**PLN140089 (Carmel Rio Road LLC)**  
**CEQA Comments regarding Draft EIR**

Review period of December 2, 2016 through January 23, 2017

Figure 2. Metered Annual Groundwater Use at the Carmel Rio Site, 1994-2014

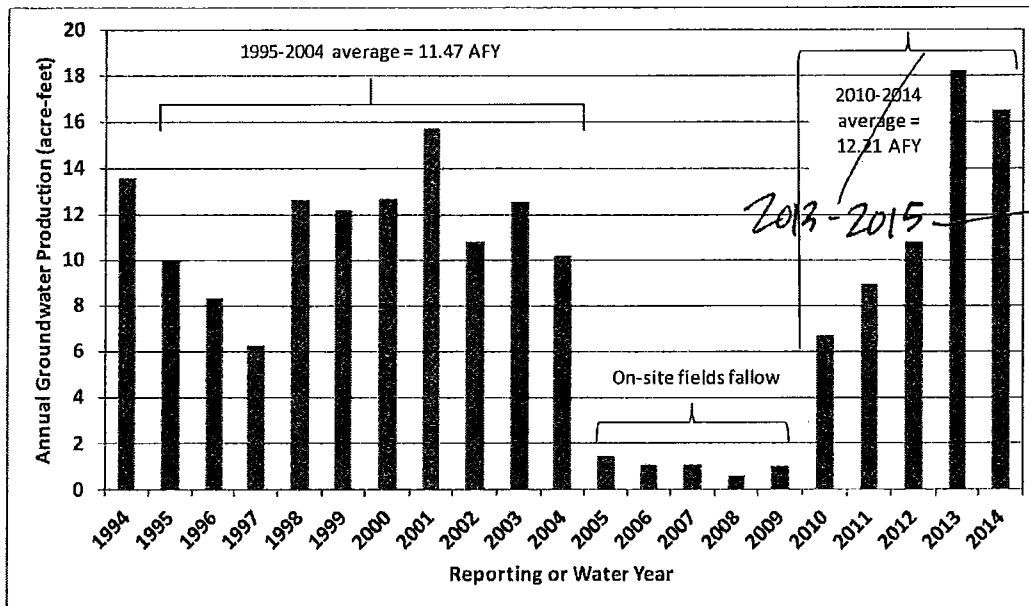
Production from wells at the site is metered and annual volumes have been recorded by MPWMD since 1994. Annual production during 1994-2014 is shown in Figure 2. Given the variability of water use during that period, it is important to select a baseline period that represents the most recent historical period prior to the beginning of the development process. The September Ranch decision expressed this criterion as follows:

Please include:

Figure 1 Daily traffic counts on Highway 1 between Carmel Valley Road and Ocean Avenue. Note that peak traffic volume does not occur during the pre-specified hours of 7-9 AM or 4-6 pm, and that southbound traffic exceeds the 1500 capacity much of the day.

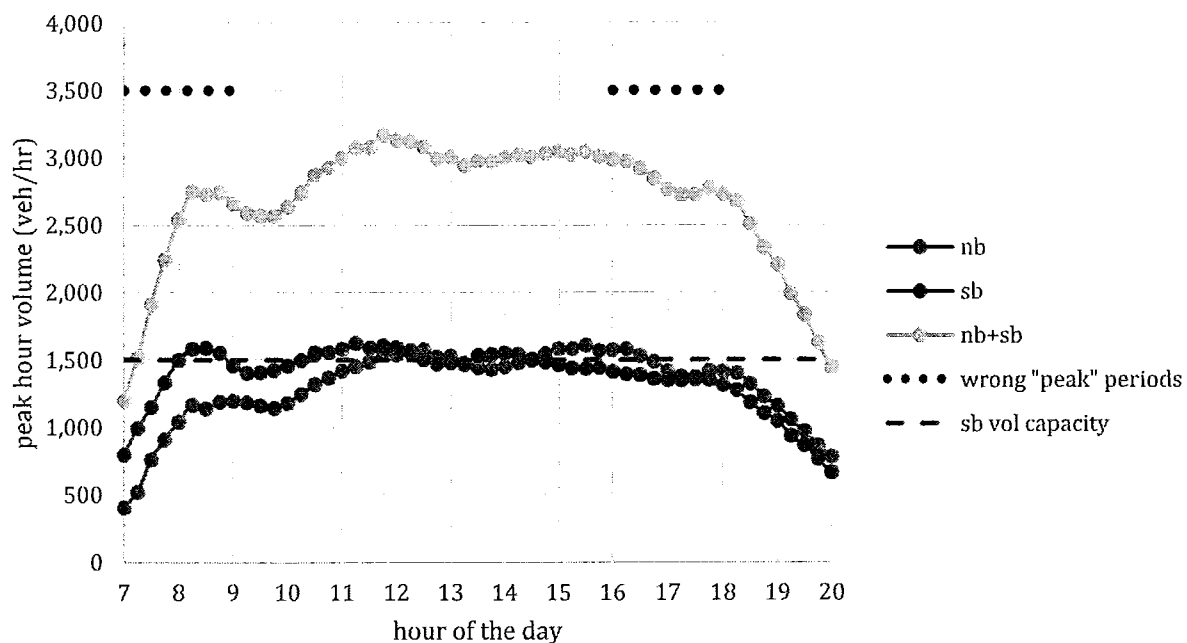
sr1, cvr-ocean; vehicle volume vs hour of the day  
(8/20/14)  
(note heaviest total traffic NOT during 7-9 AM, 4-6 PM)

hours of the day, with the peak occurring near midday (see Figure 1); the correct LOS assignment for the segment accordingly is LOS F, as determined by the proper application of MMLOS indicated in Note 1 to Exhibit 1 on p.6 of the Users Guide.
